ADDENDUM

Project: Fiber Cable Replacement

Addendum No.: 1

AES Project No.: DCS# 2315A / AES 23152

Sheet E2.00 – FIBER ONE LINE DIAGRAM & DETAILS

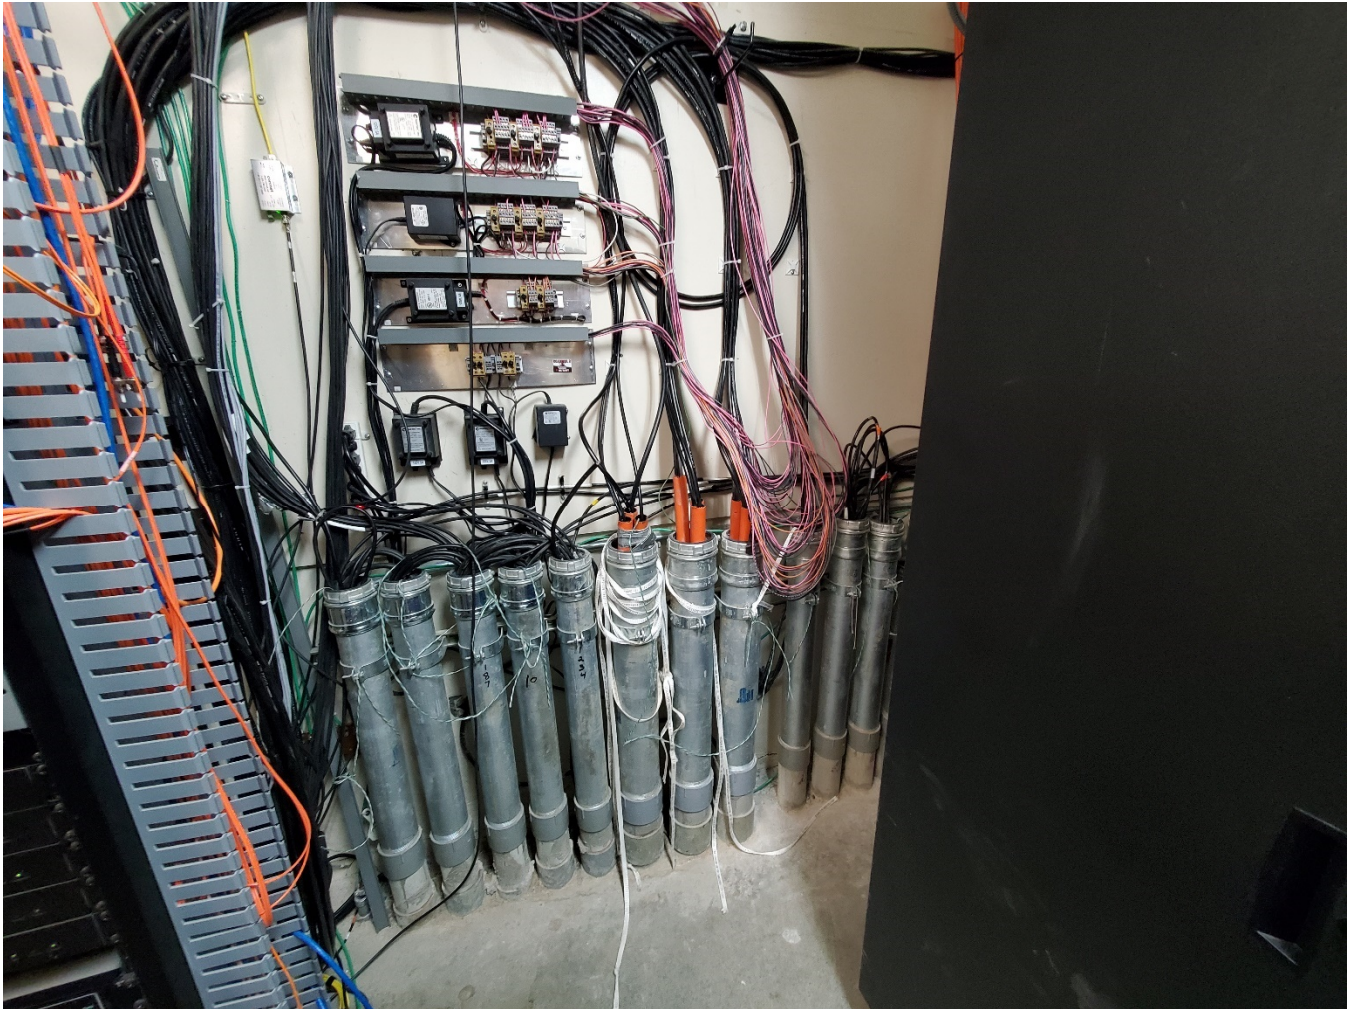
1. Detail D13 and D14 revised to reflect, two 48 port fiber splice cassettes in each rack, not just one.
